ADDENDUM NO. 01
MACOMB COUNTY JAIL
LAUNDRY HOT WATER STORAGE
TANKS AND BOILER REPLACEMENT
Page 1 of 3 (write up only)

November 10, 2023

ADDENDUM NO.01 to the plans and specifications for the Macomb County Jail, Laundry Hot Water Storage Tanks and Boiler Replacement, Mt. Clemens, MI, Architect's Project No. 231997, dated October 25, 2023.

PRELIMINARY	<input type="checkbox"/>
DESIGN DEVELOPMENT	<input type="checkbox"/>
CONSTRUCTION	<input checked="" type="checkbox"/>
FINAL RECORD	<input type="checkbox"/>
DRAWN BY: LSA	
CHECKED BY: LSA	
REVISIONS	
DATE: OCTOBER 25, 2023	
SHEET NO:	
A1.1	
JOB NO:	231997

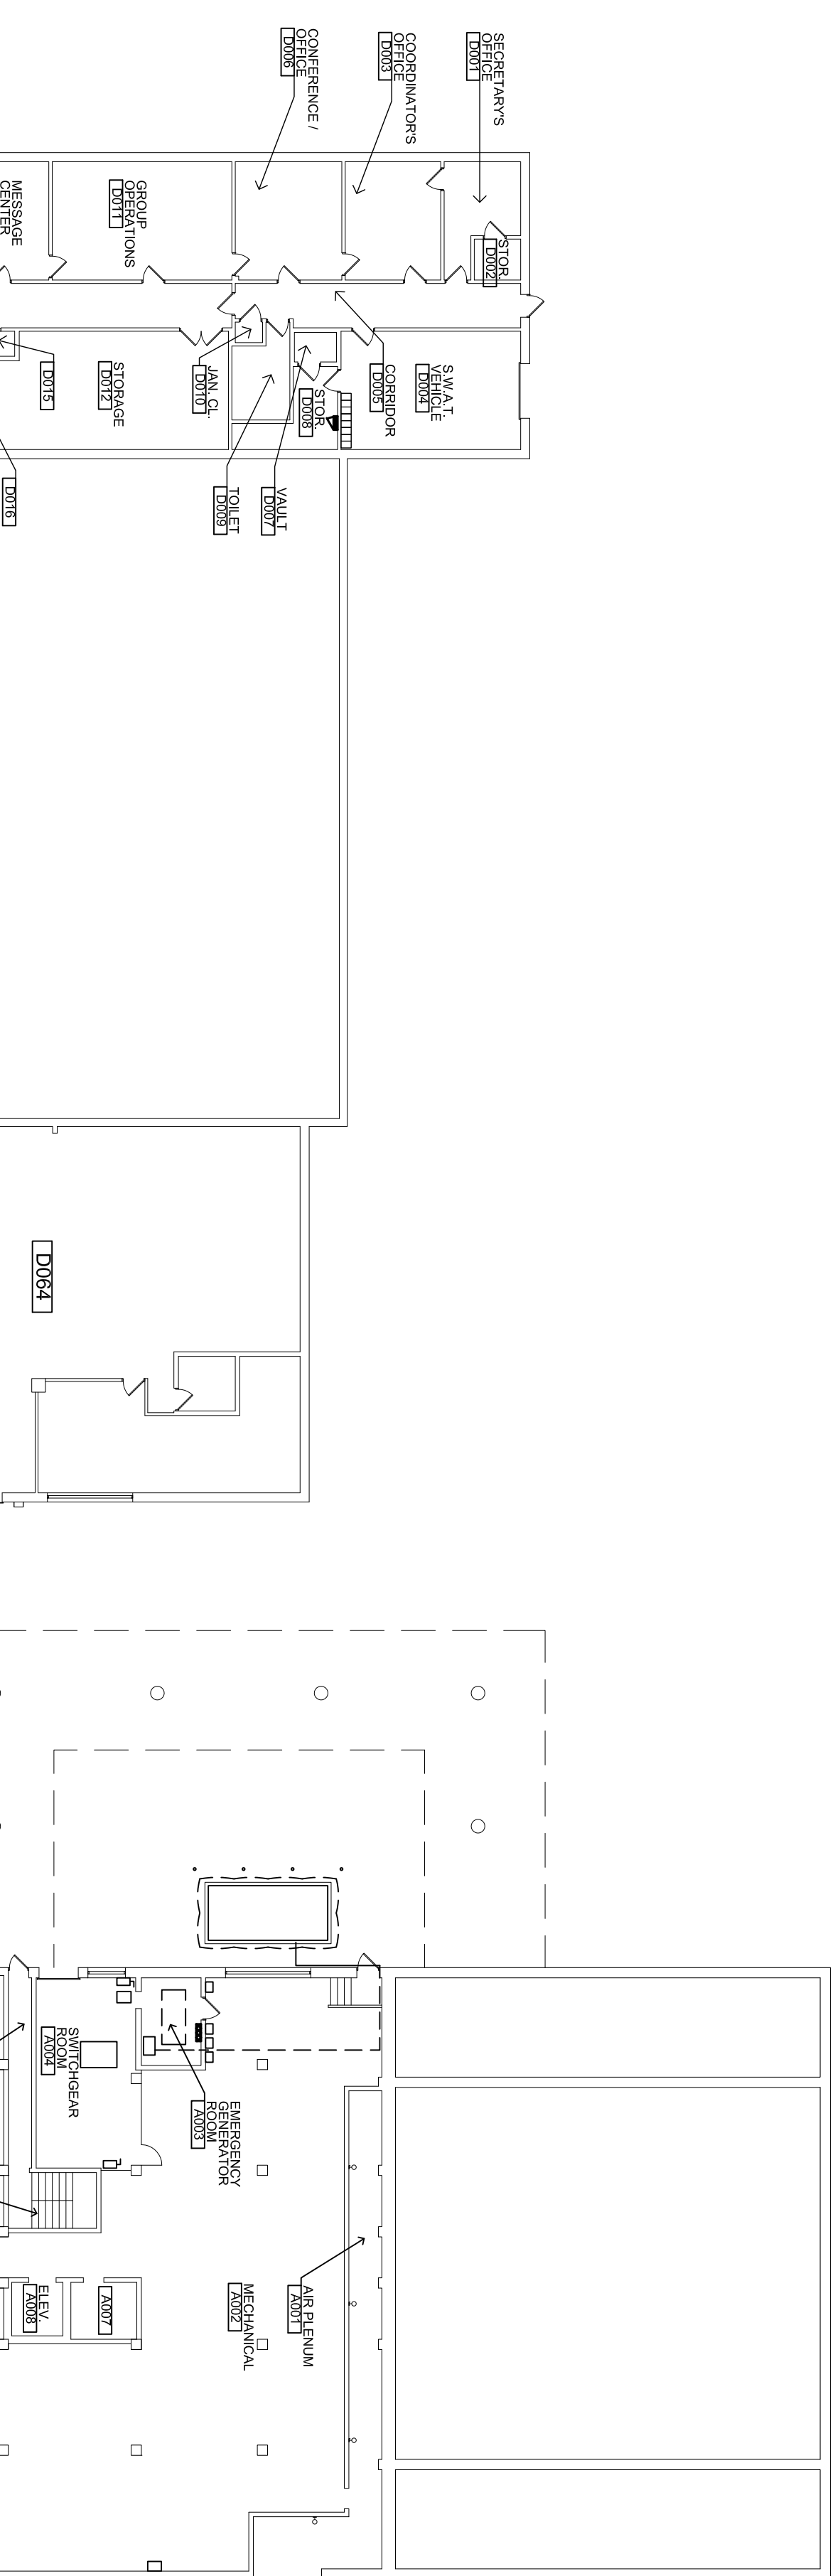
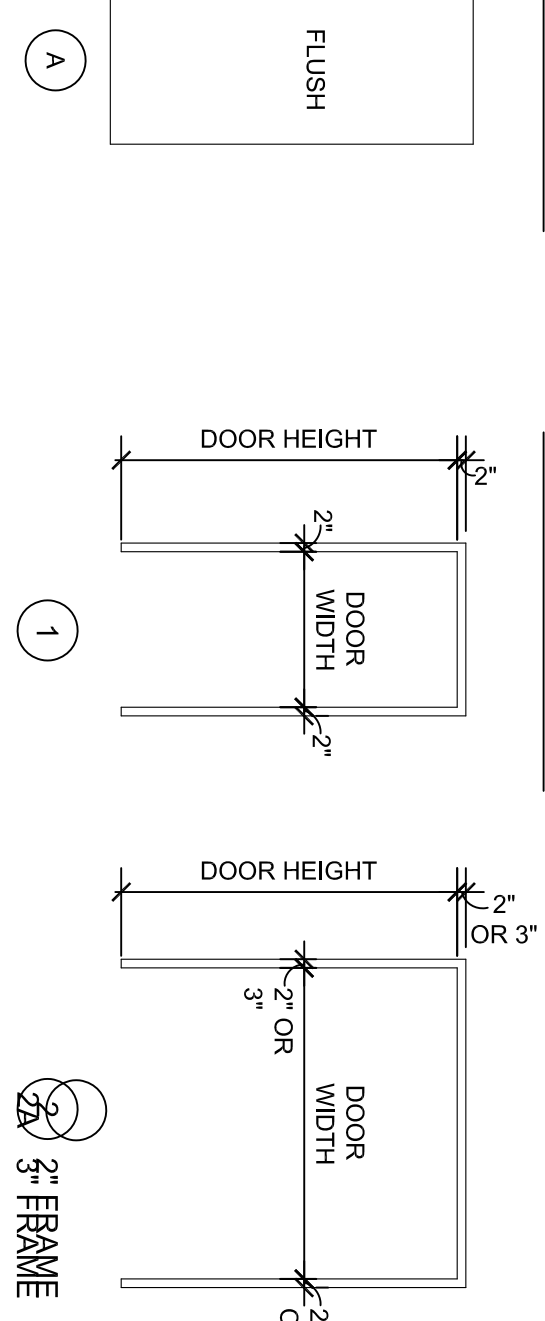
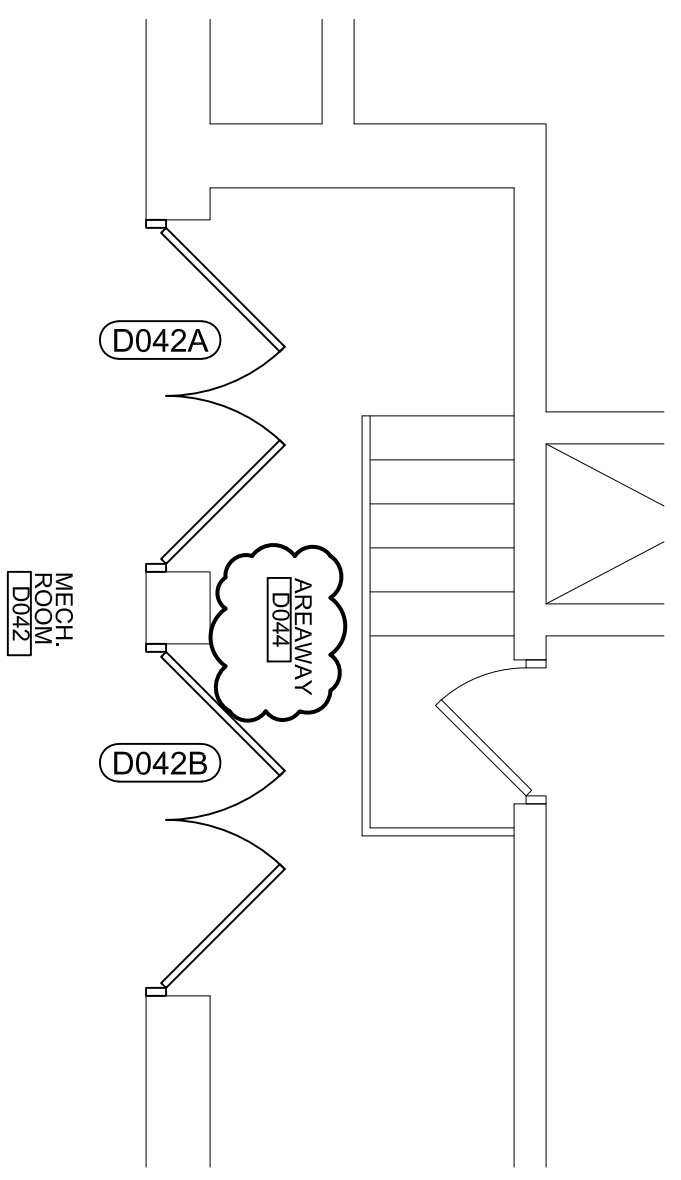
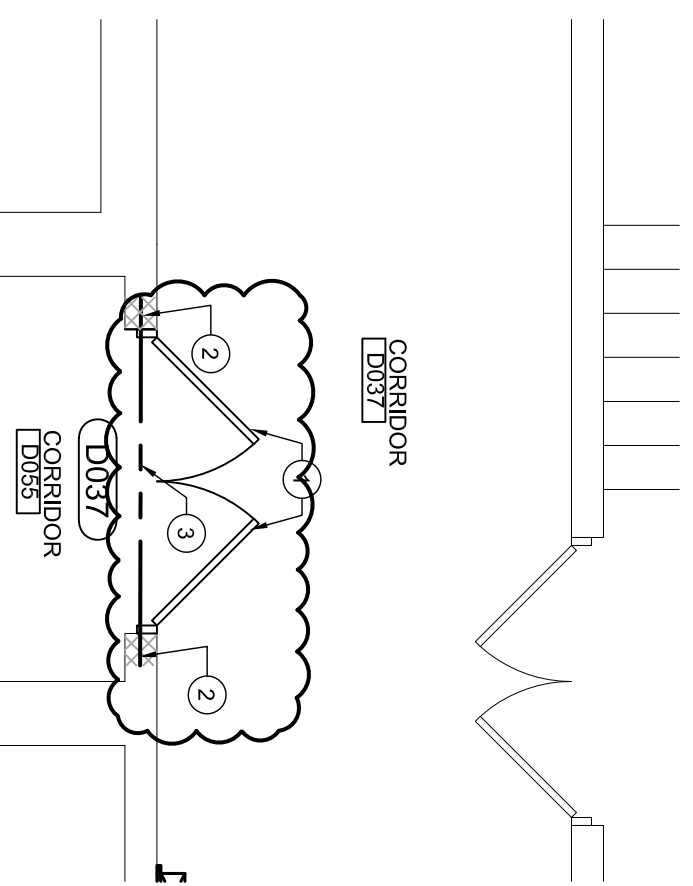
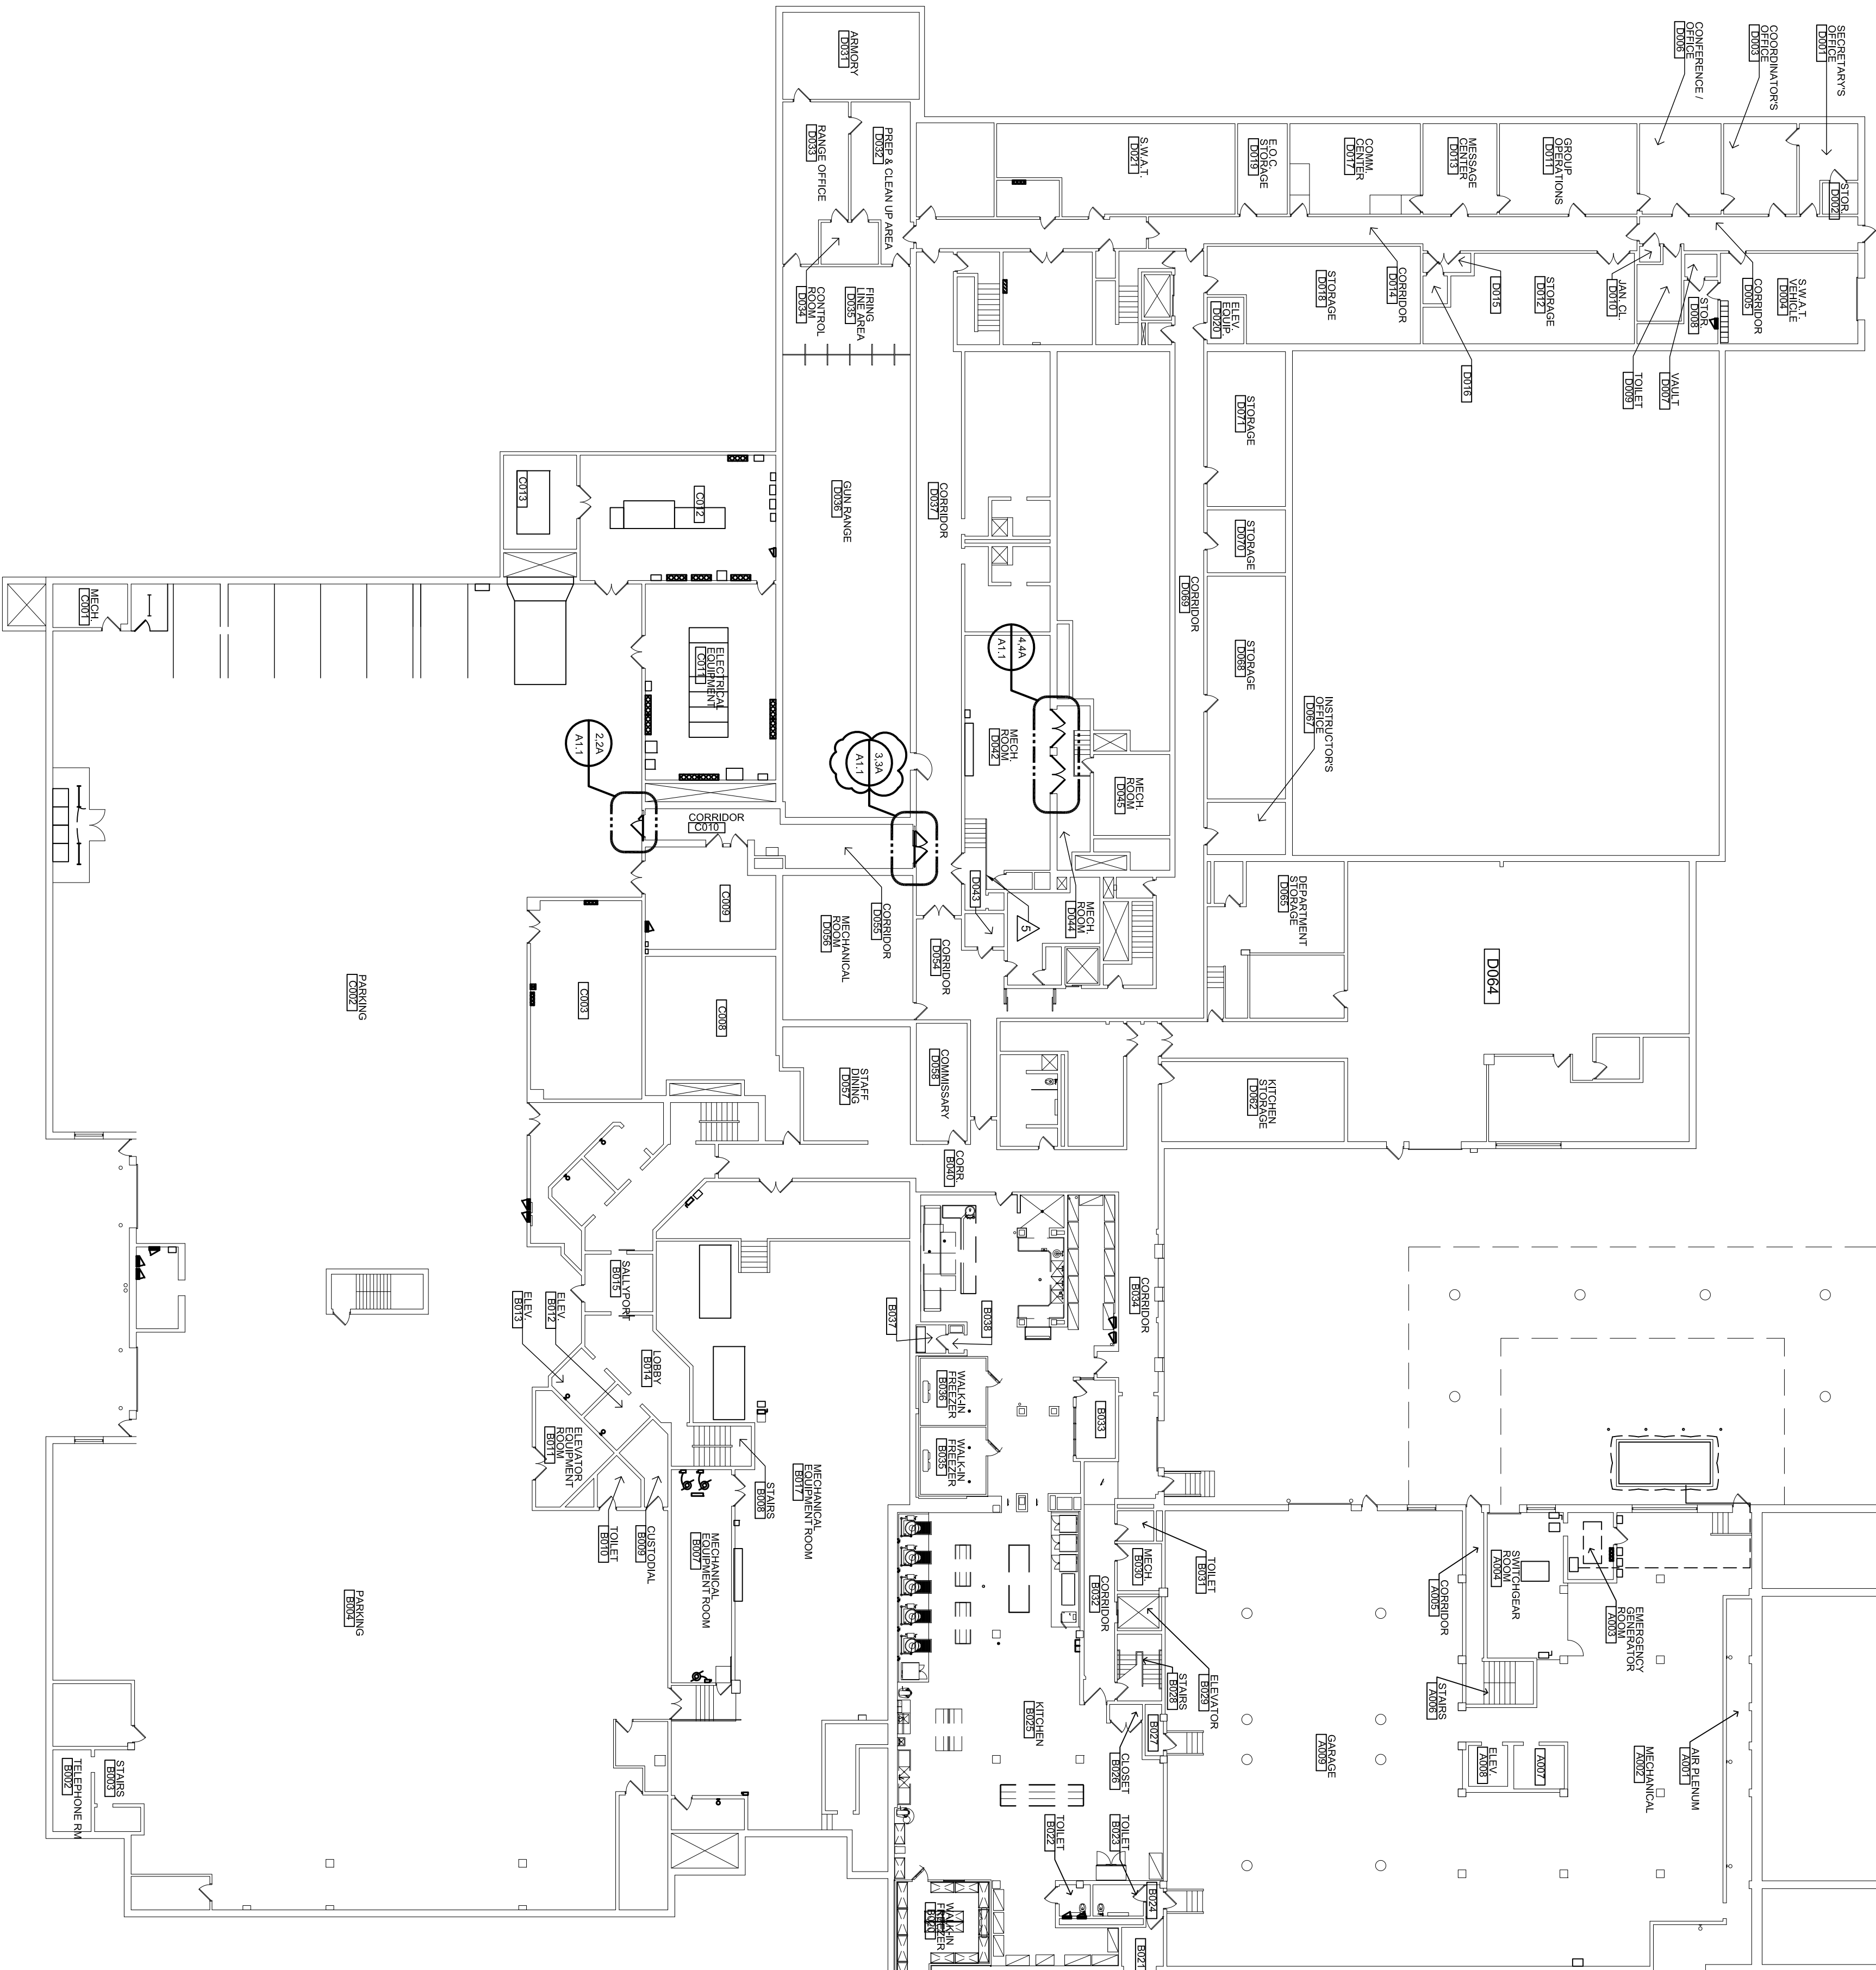
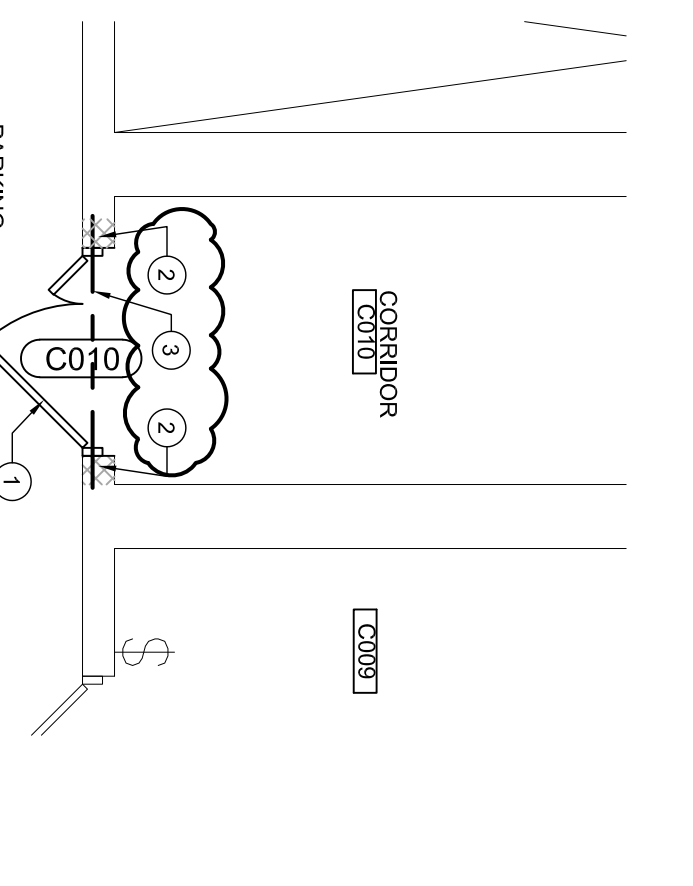
- ITEM NO. A1:** Refer to Sheet A1.1 (Re-issued):
1. Corrected Alternate and enlarged floor plans.
 2. Corrected composite floor plan.
 3. Removed Enlarged Plan 3A1.1.
 4. Revised Door Schedule Remark 3.
 5. Revised Demo Note 4

3. Drawing ME4.02 was not issued, please have the architect issue the drawing. **It is being issued with this Addendum.**
4. Drawing A1.1- Detail 3/A1.1 Demo Note#4 indicates Alternate #2- Remove portion of existing CMU Wall and existing lintel for new door. Demo Note #1 indicates remove existing hollow meta frame, door, and hardware complete. **See Item No. A1 of this Addendum.**

5. Drawing A1.1- Detail 3A/A1.1 Base Bid Enlarge First Floor Plan New Work Plan- indicates to remove and replace Door D037. Detail 3B/A1.1 Alternate #2 Enlarge First Floor New Work Plan indicates to replace Door D037 with a double door. Should detail 3/A1.1 be indicated as Alternate #2 Demo Plan? **See Item No. AS1 “D” of this Addendum.**
